April 17<sup>th</sup>, 2013

ATTN: Rebecca Stack  
District Department of the Environment  
1200 First Street NE  
Washington DC 20002

**RE: Revised Stormwater Guidebook Comments**

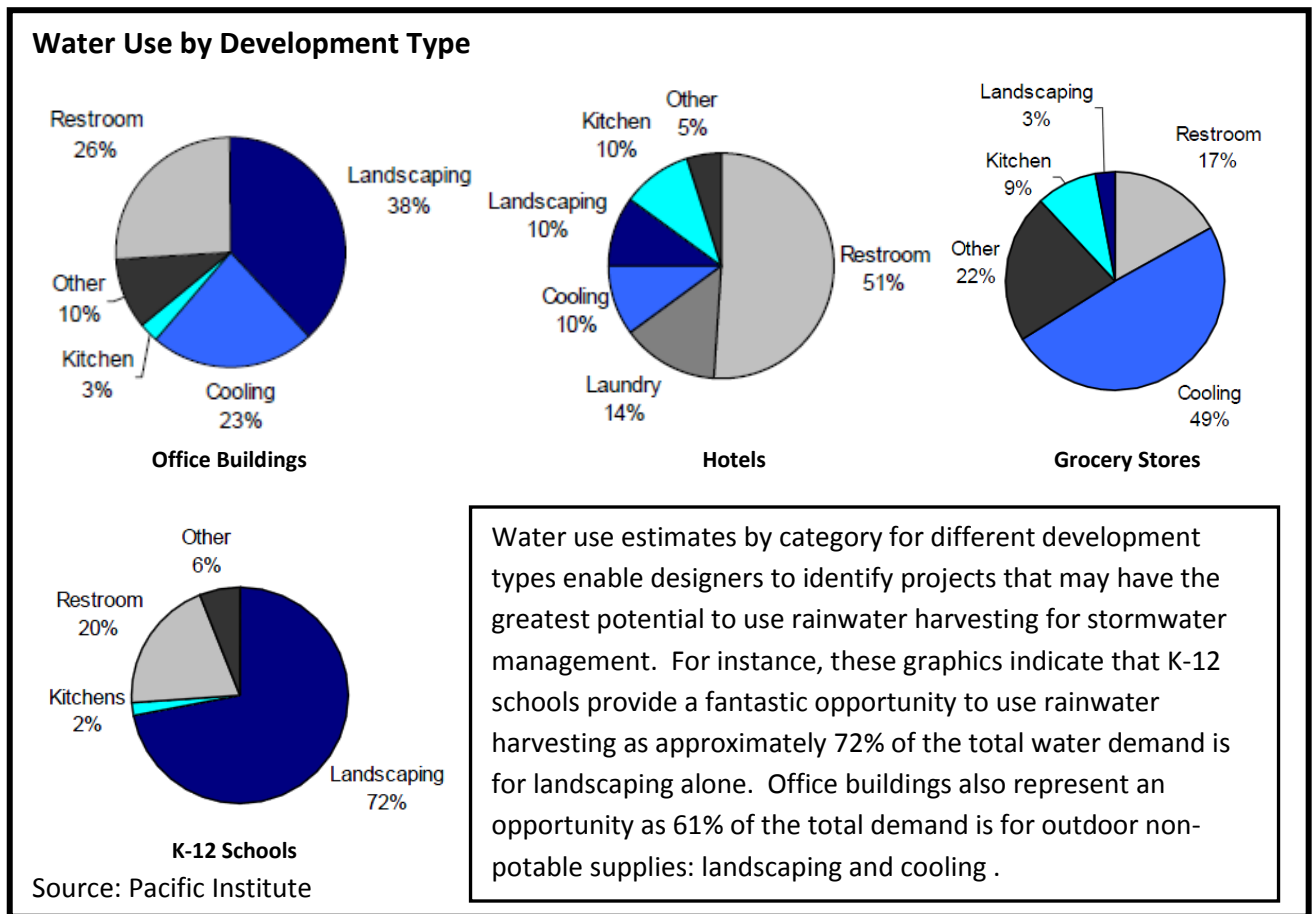
- d. Enable designers to better envision which development types may have greater water uses and hence be most amenable to rainwater harvesting for SWM purposes. For example, the Pacific Institute provided the following estimates in the graphic below.

Source: (Forasté 2011) LID Symposium; ORISE/US EPA

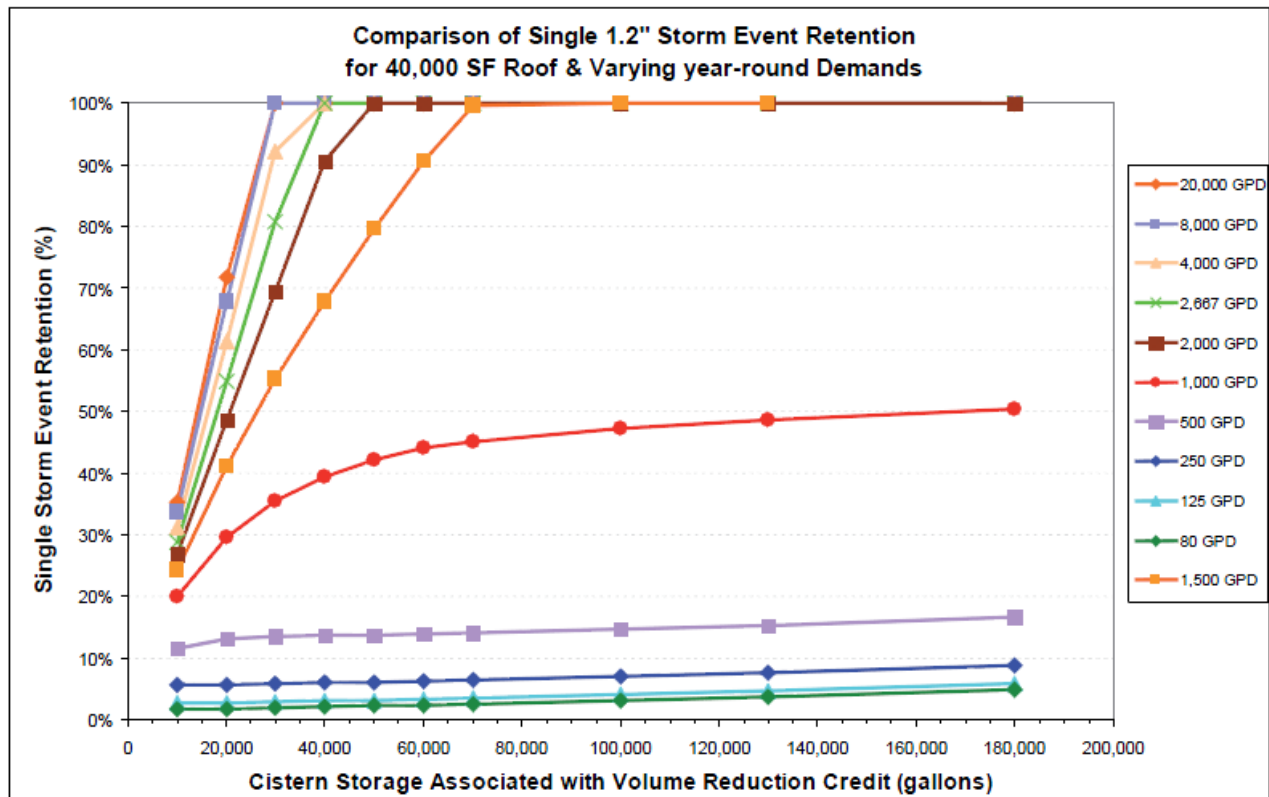
27.) **Sensitivity Analysis – Water Use and SWM Retention Credit:** Stormwater management retention credit is closely linked and dependent upon water demands. The chart below plots stormwater retention versus cistern size, using the Cistern Design Spreadsheet (CDS). Each line on the plot represents a different water demand from a site ranging from 80 gallons per day (gpd) to 20,000 gpd year-round, capturing rainwater from a 40,000 SF rooftop. As expected, the retention is great for large water demands for small to large cisterns, while the retention is small for small water demands regardless of the cistern size. The significance of this graphic is that retention credit is largely driven by demand; without it, the maximum retention is limited no matter how much the cistern size is increased. This comment is provided in the same context as the one above on the utility of providing water use estimates.
